NUMBER: 84-15

- A. Merc 3.5/3.6 Salt Water Use
- B. New Spark Plug Recommendations
 - Merc 3.5
 - Merc 18XD & 25XD
 - Mariner 20-25 (U.S. built)
- C. Rework of Bearing Journals

**Figure 1 (before)****Figure 2 (after)**

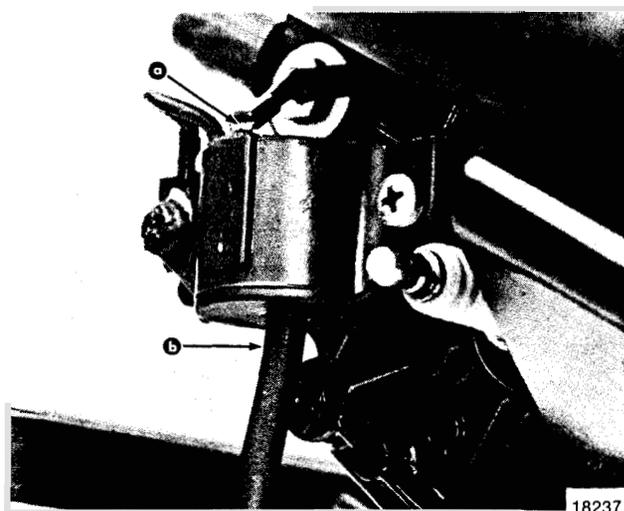
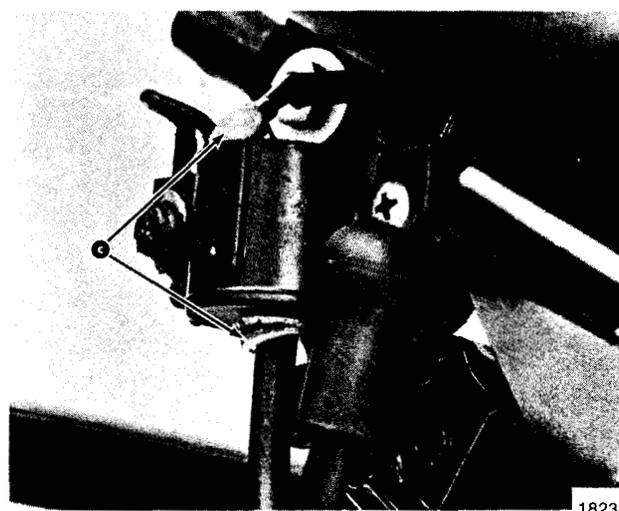
In rough water or following seas, it's possible for the ignition coil to become drenched with seawater which could cause rough running or stalling. The coil primary (wire from module) is as critical as the spark plug wire.

Use Insulating Compound C-92-41669-1 to seal, waterproof and insulate the ignition coil. Figures 1 and 2 illustrate "before" and "after".

1. Remove top cowl for easier access to ignition coil.
2. Turn spark plug wire counterclockwise to remove from ignition coil.
3. Apply Insulating Compound, C-92-41669-1 approximately $\frac{1}{8}$ " from end of spark plug wire, then thread spark plug wire clockwise into ignition coil.
4. Remove black primary (module) wire from ignition coil.
5. Apply Insulating Compound C-92-41669-1 to base of primary terminal on ignition coil and reinstall black primary (module) wire.
